Bradley Heights Apartments

A 236-Unit Apartment Development Puyallup, Washington

Staff: RNBrown

Date: 03/24/2025

SITE PLAN

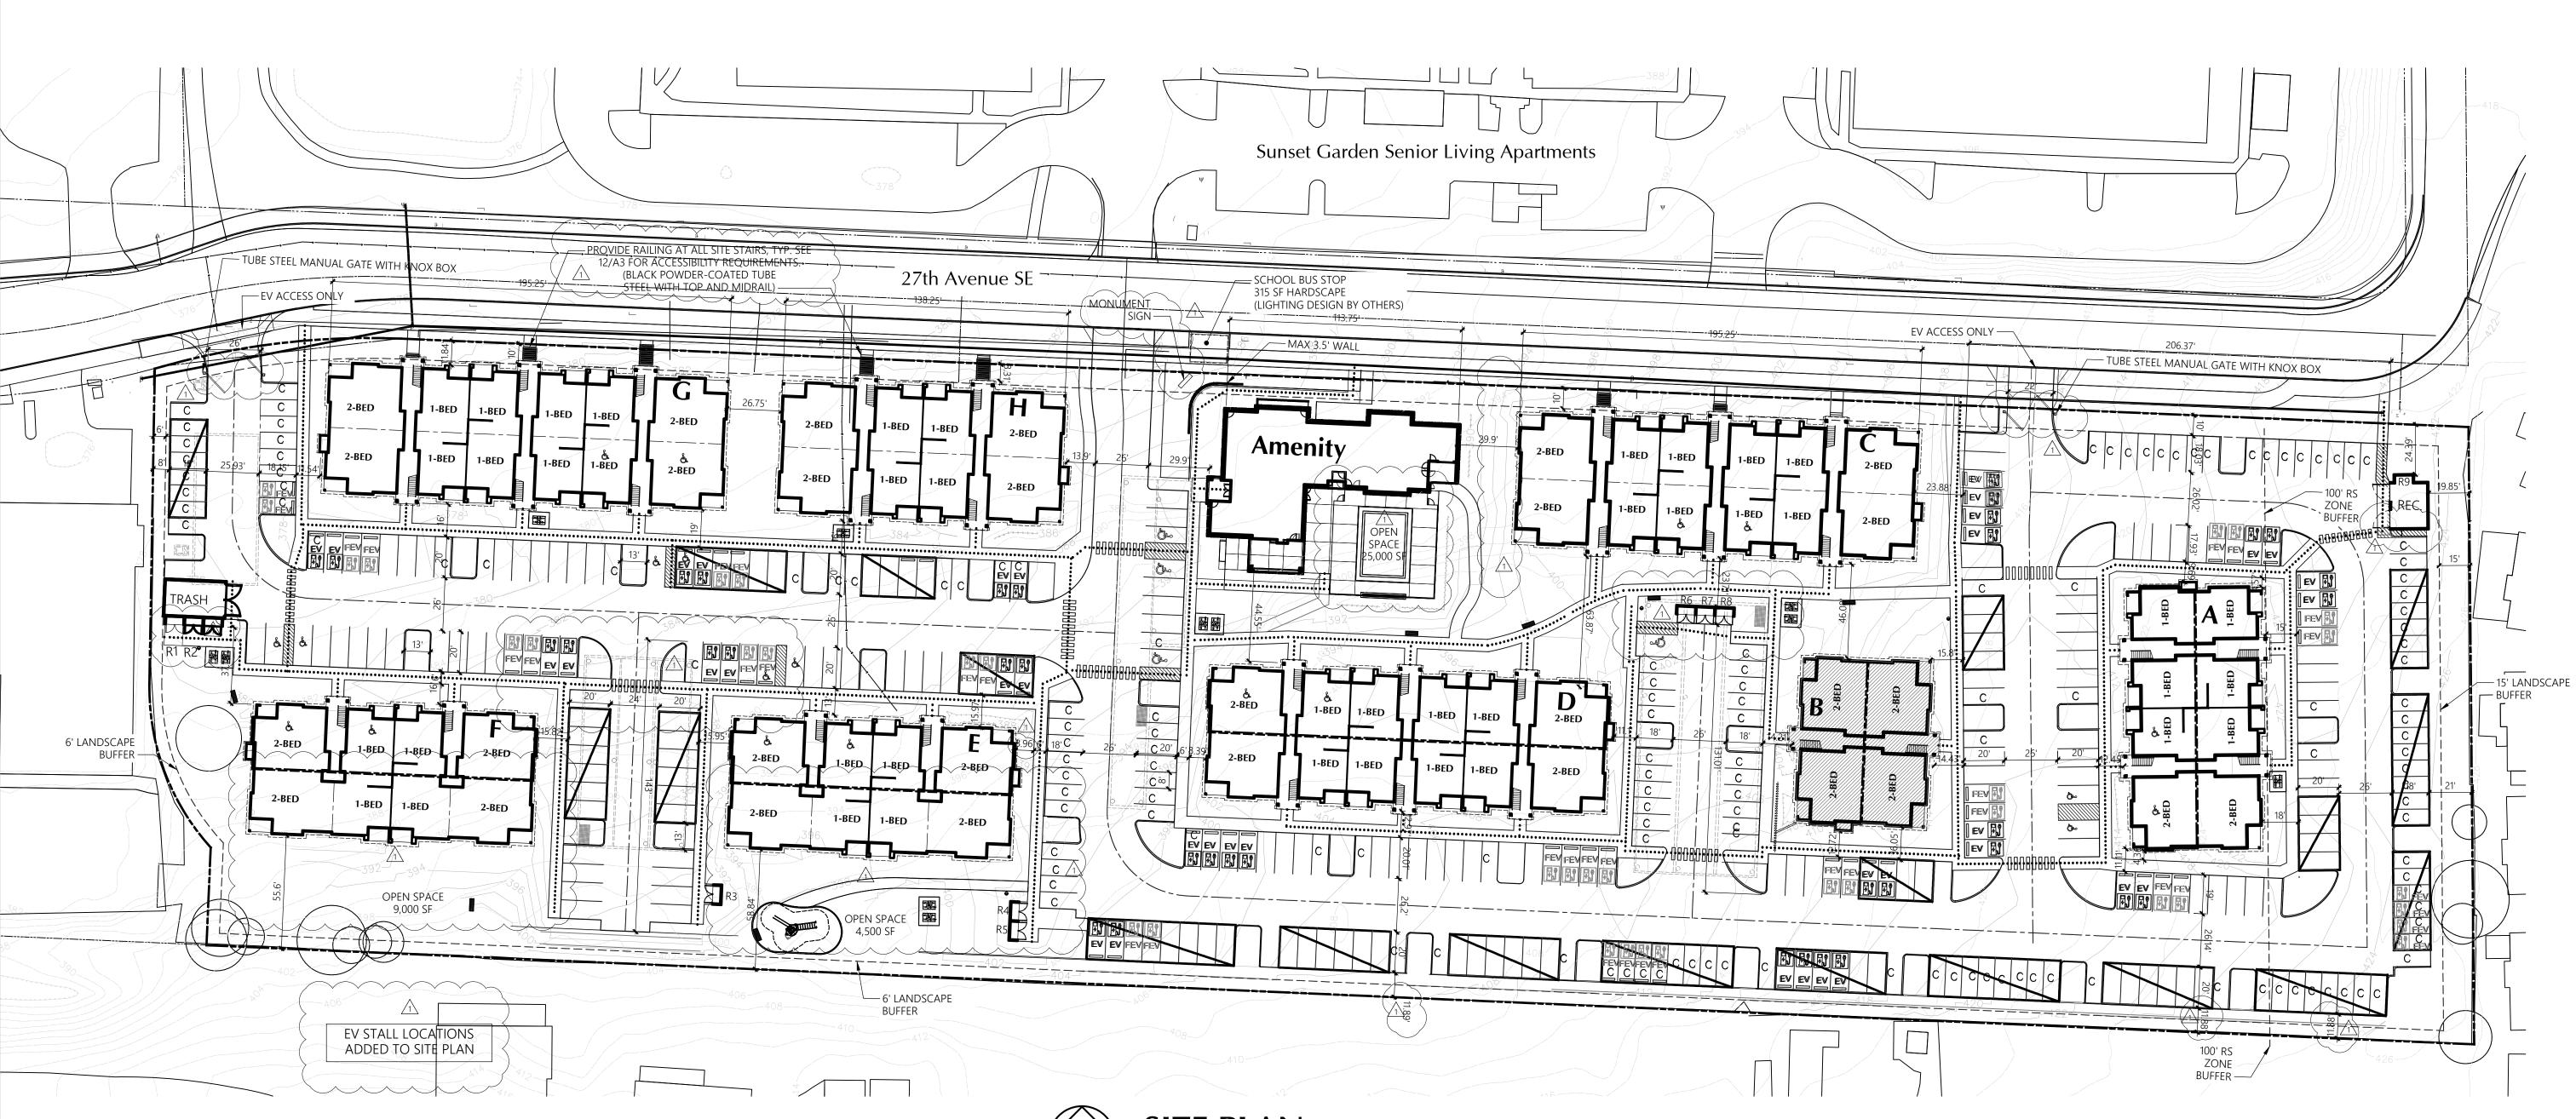
Provide at least 1 accessible parking space for each Type A unit per Washington State Building, Section 1106.2 and insure that the accessible parking spaces are on the shortest accessible route of travel per Washington State Building Code Section 1106.6. See accessible parking for buildings C and D as an example, there may be others.

Provide a definition of "future electric vehicle charging stall infrastructure" as listed on the Site Key.

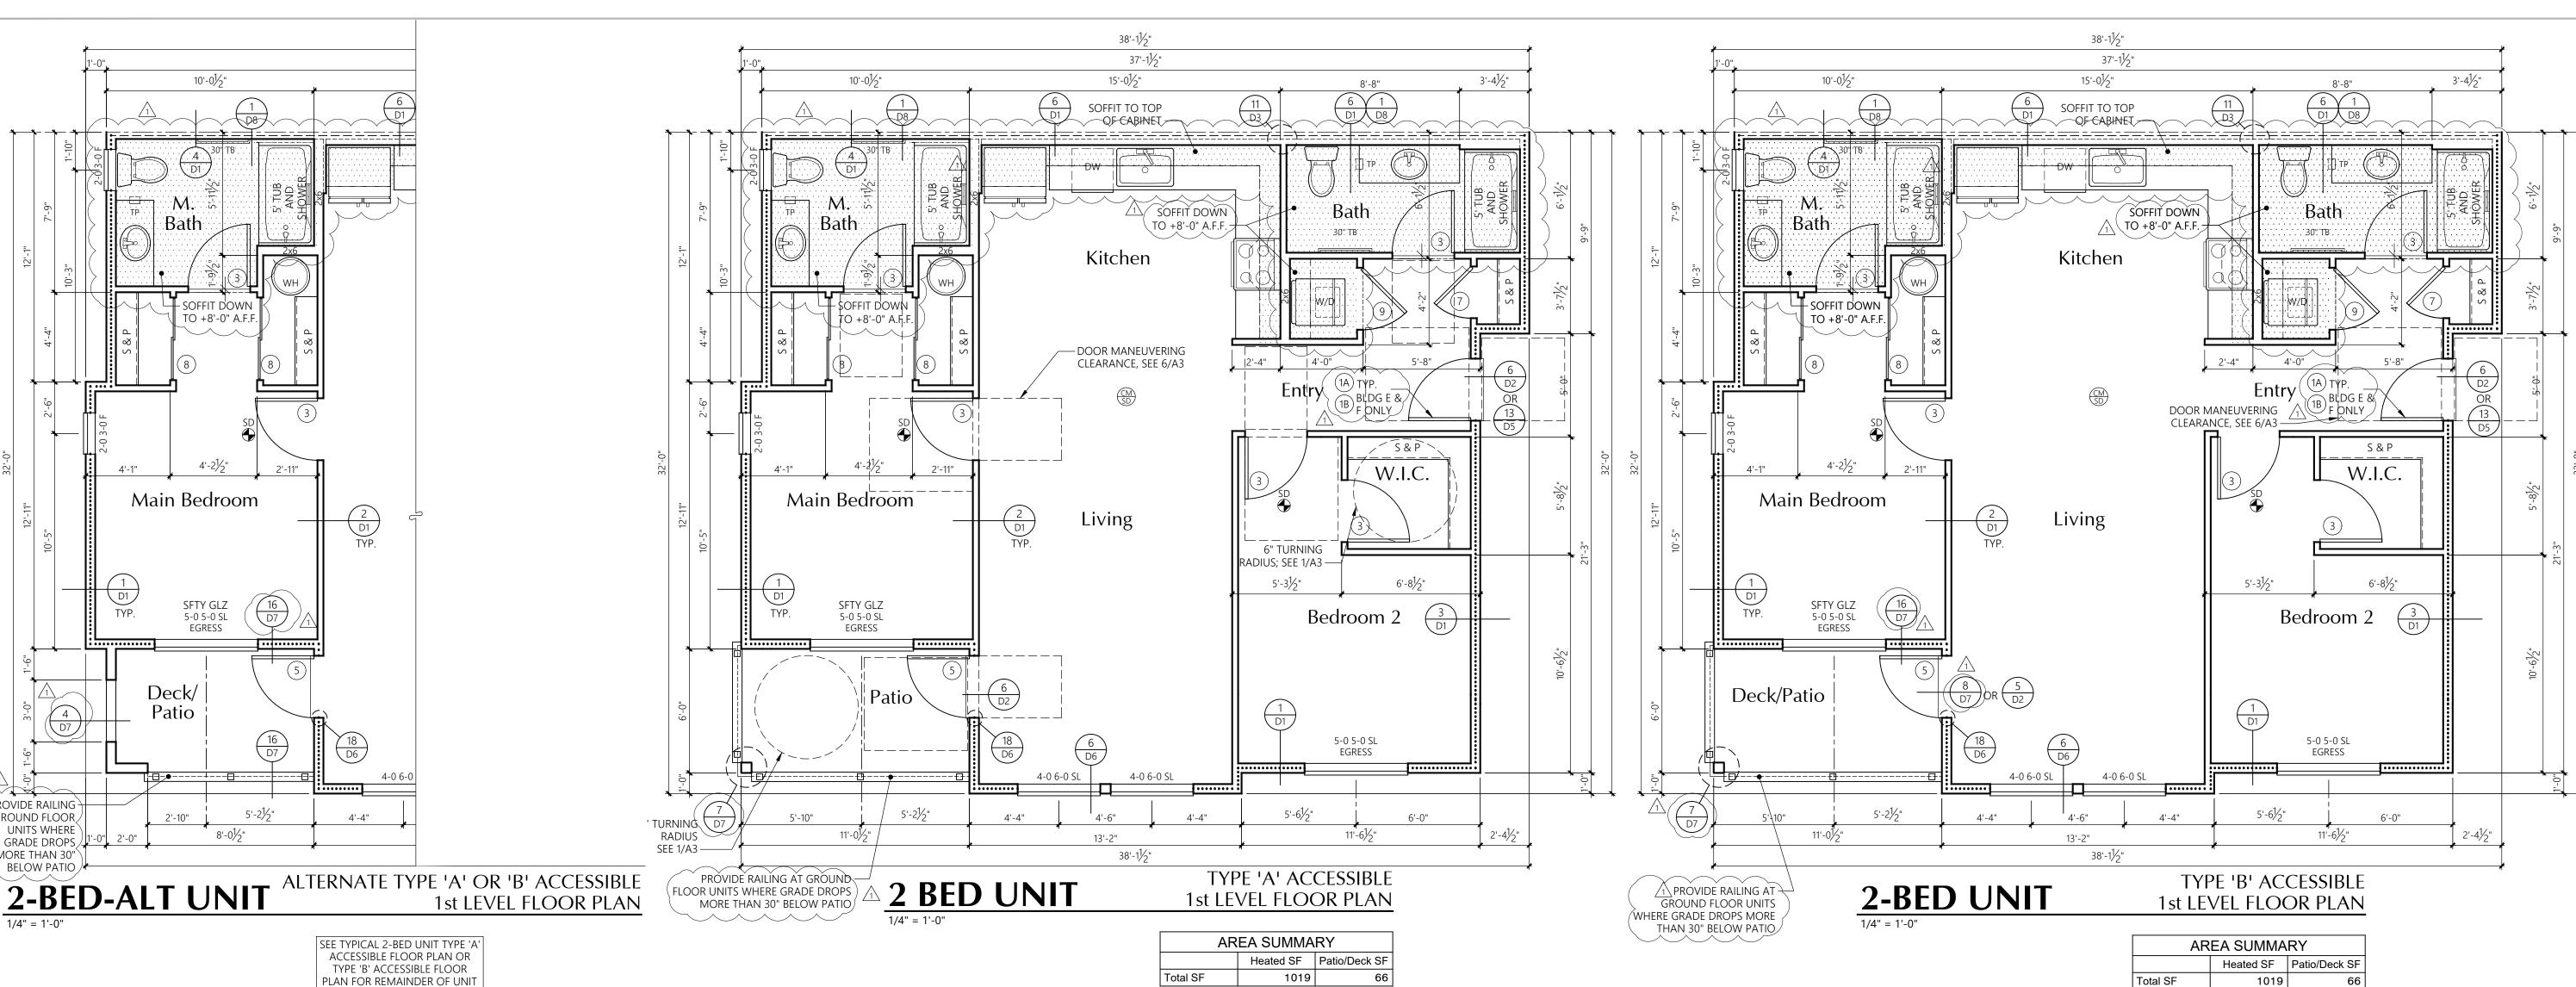
______ Unit Plan Notes state that no plumbing shall be located in the 1" air gap. See plumbing plans

Unit Plan Notes identify that R-13 insulation will be provided on 1 side U.N.O., but detail 4/D1states to insulate both sides U.N.O. Please clarify if the wall will be insulated on both sides or one side only.

Door Key references Sheet U13 update plan or sheet numbers as needed, as there is no Sheet

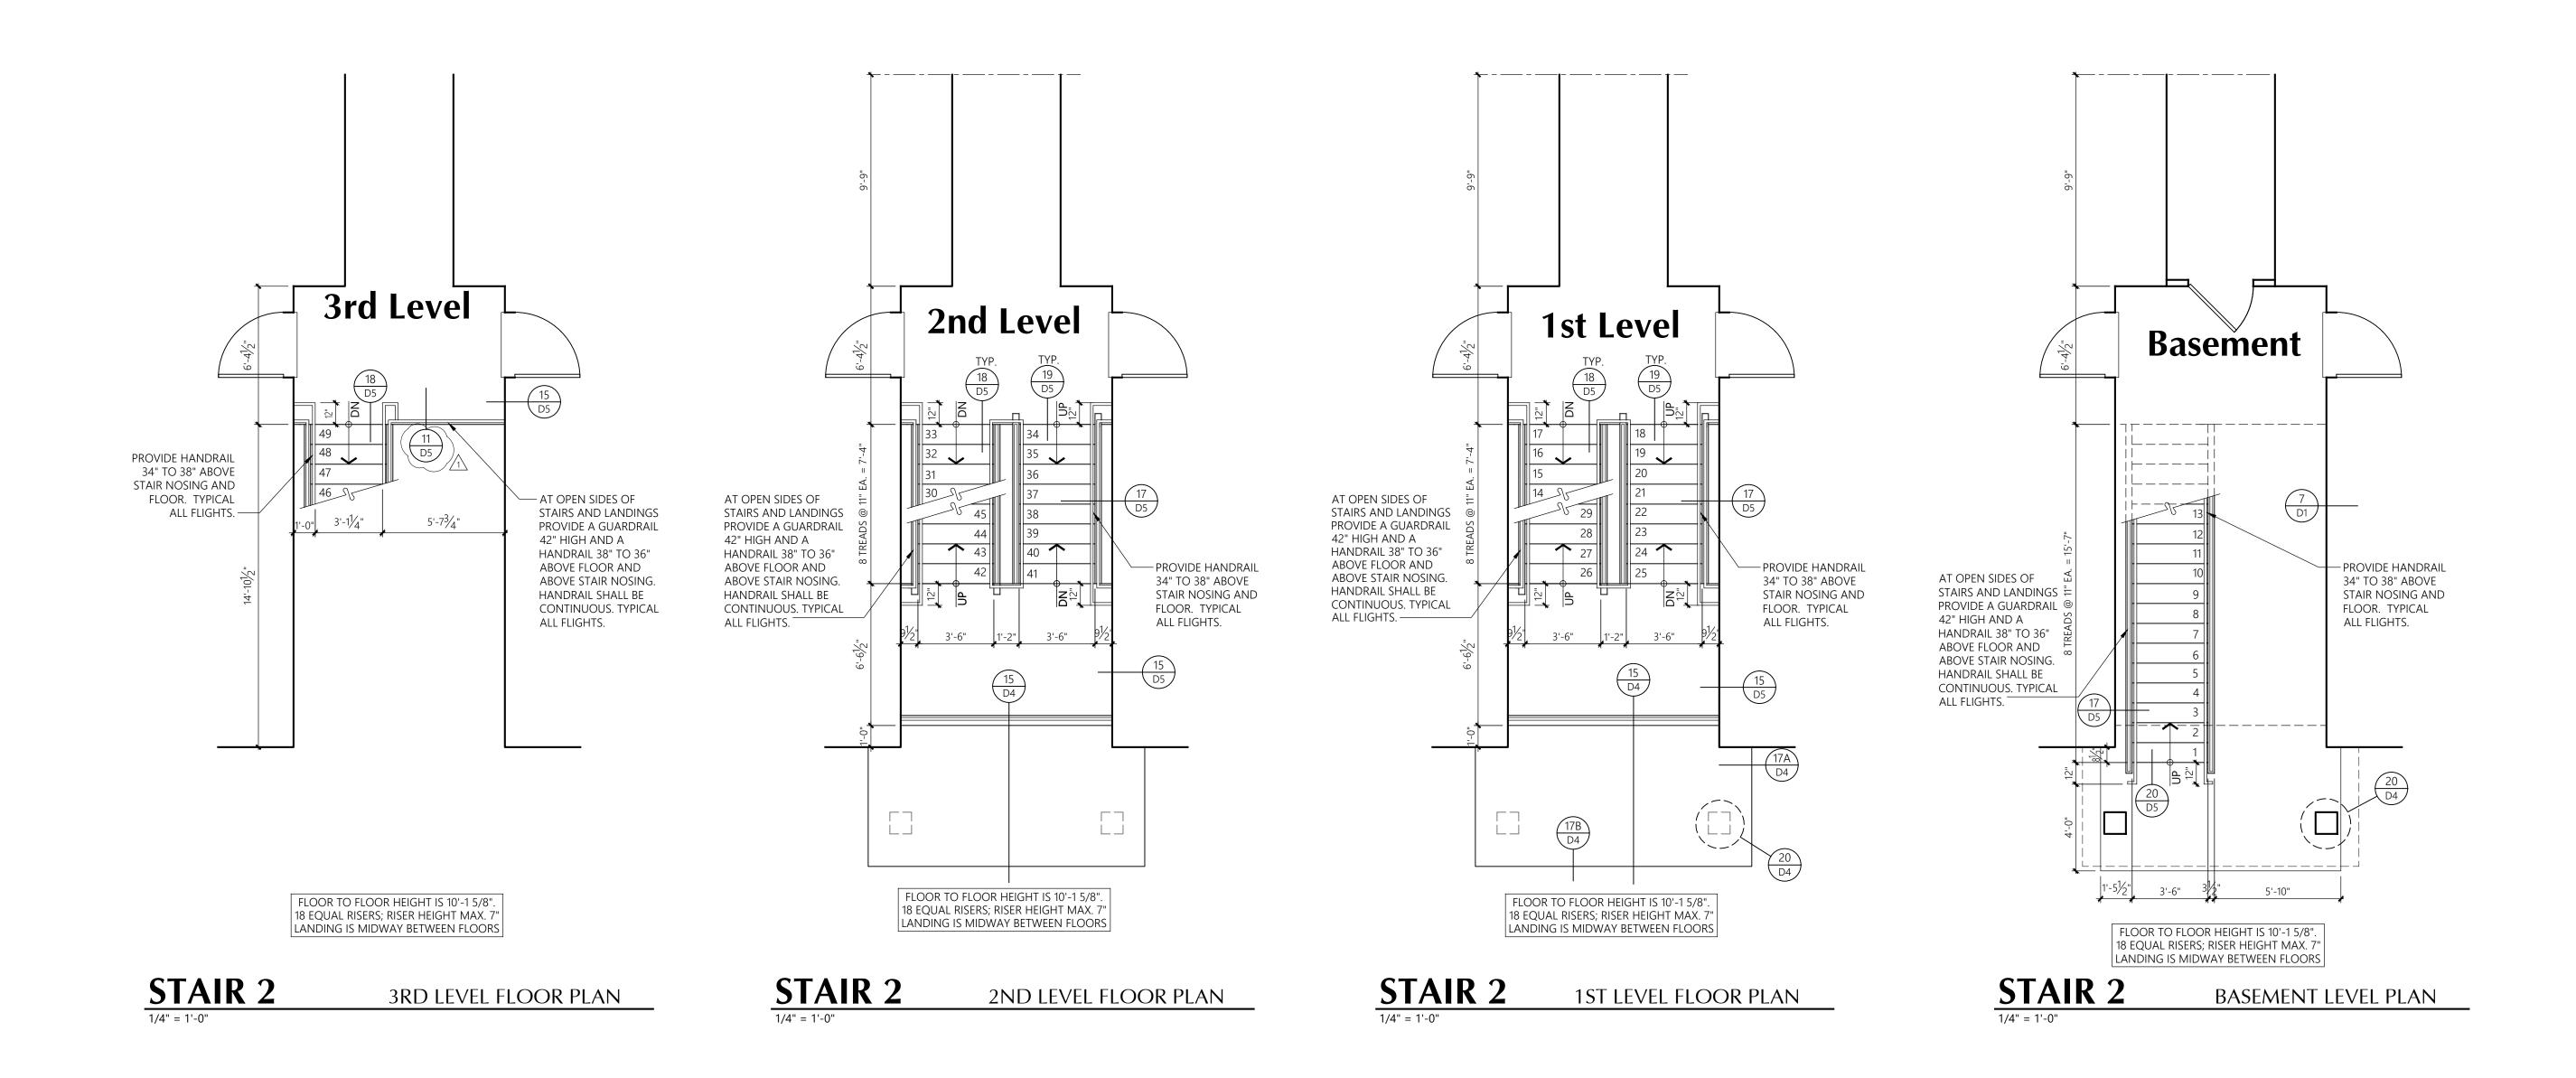
Review and clarify instances where header

height will change as the header height is

called out as 8' U.N.O. in Unit Plan Notes.

Example 2 Bed Unit on Sheet U4 has a furred down ceiling. Review other units for additional instances and adjust if necessary.

ROOF PLAN

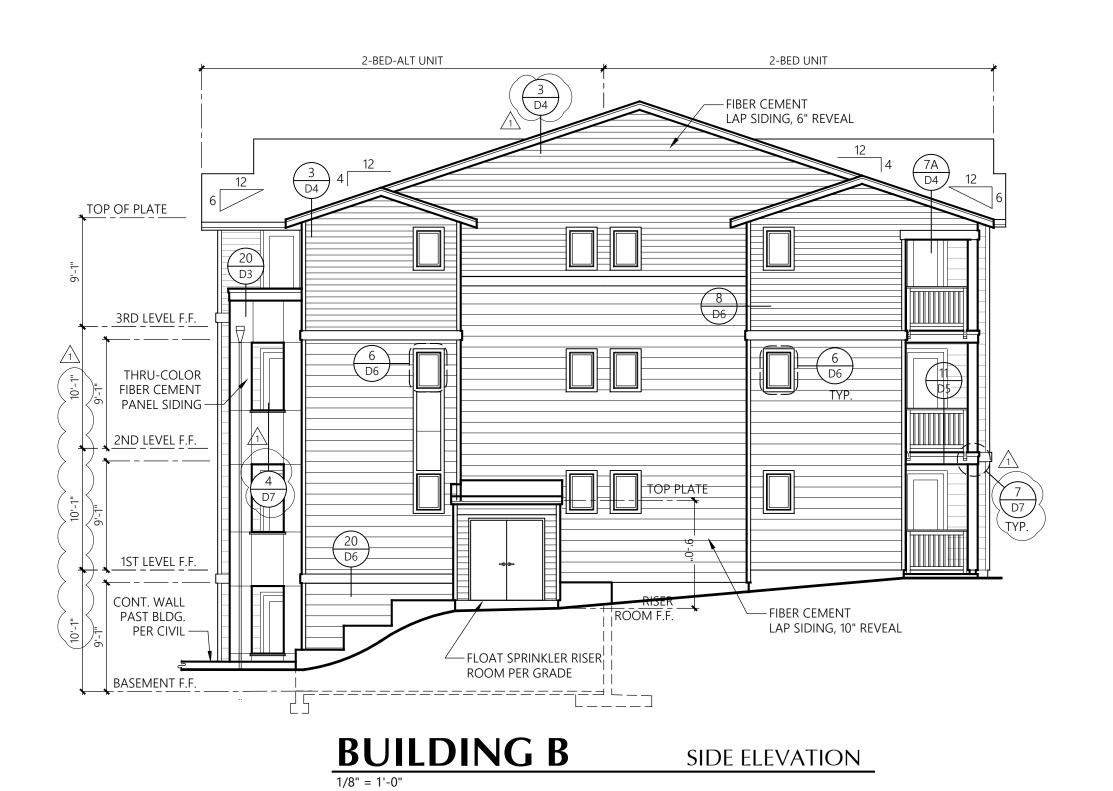
Detail and show draftstops in attic as needed per Washington State Building Code, 708.4.2. Update the attic ventilation as needed based upon changes for draftstops.
